Access Compliance Report

Public Rights-of-Way

Intersection ID: 48454	Main Street: RED_RUST_LN	Cross Street: GOLF_LINKS_DR	Location: SW
ADA ID: BBE5858746C3	Ramp Type: Perp	Initial Pass/Fail: Pass	Overall Compliance: No
		Severity Score: 5

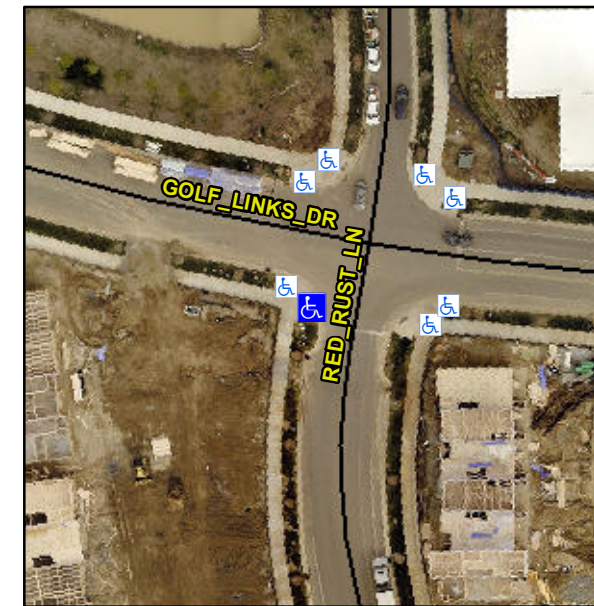
Not Found, R304.5.3, R304.5.4

**Remove & Replace Entire Ramp.
Remove & Replace Gutter.**
